Tuesday, August 3, 2021
PERMIT MODIFICATION APPROVAL
Horizontal 6A / New Drill

Permit Modification Approval for RAPIDS UNIT 2H

47-095-02738-00-00

Extend Intermediate/Coal String 3050'.

- ➤ REVISED Form WW-6B
- REVISED Mylar Plat

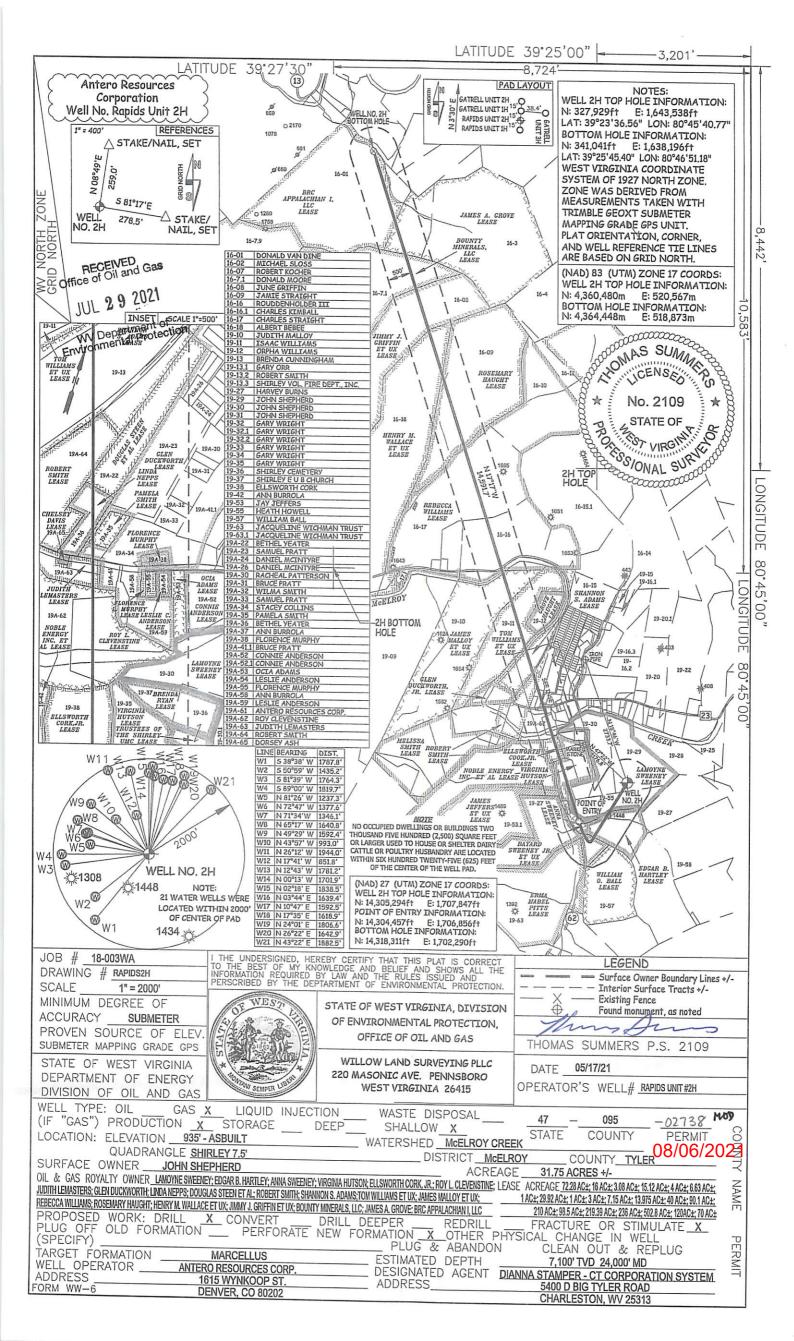
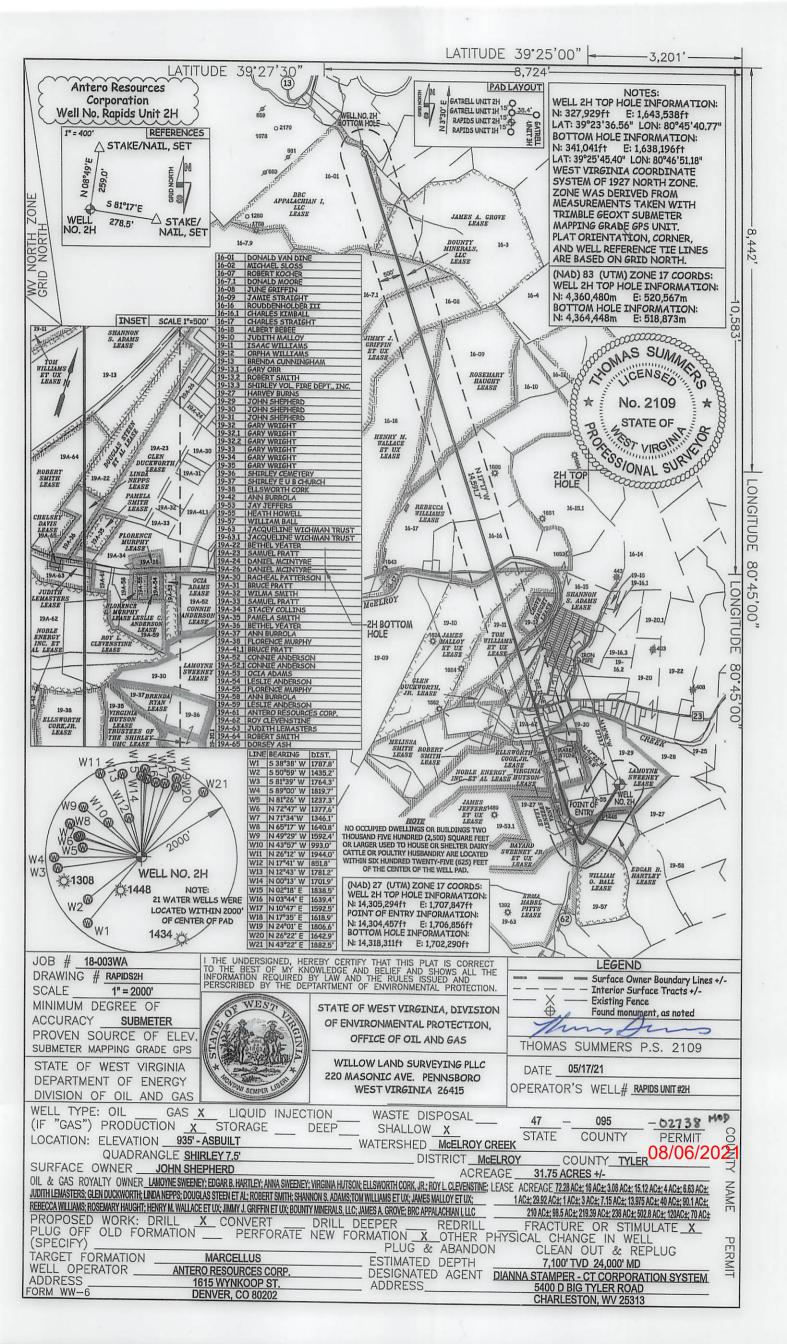
Antero Resources Corporation (Antero) would like to submit the following permit modifications for approved well on the Shepherd Pad. We are requesting to extend the wellbore casing for the coal/intermediate string.

TYPE	Size (in)	New or Used	<u>Grade</u>	Weight per ft. (lb/ft)	FOOTAGE: For Drilling (ft)	INTERVALS: Left in Well (ft)	CEMENT: Fill-up (Cu. Ft.)/CTS
Conductor	20"	New	H-40	94#	80	80	CTS, 77 Cu. Ft.
Fresh Water	13-3/8"	New J-55 54.5# 300		300	CTS, 417 Cu. Ft.		
Coal	9-5/8"	New	J-55	J-55 36# 3050		<del>3050</del>	CTS, 1242 Cu. Ft.
Intermediate	-		54			1 1 1 1 1 1 1 1 1 1 1 1 1 1 1 1 1 1 1 1	3
Production	5-1/2"	New	P-110	23#	24000	24000	CTS, 6191 Cu. Ft
Tubing	2-3/8"	New	N-80	4.7#			
Liners
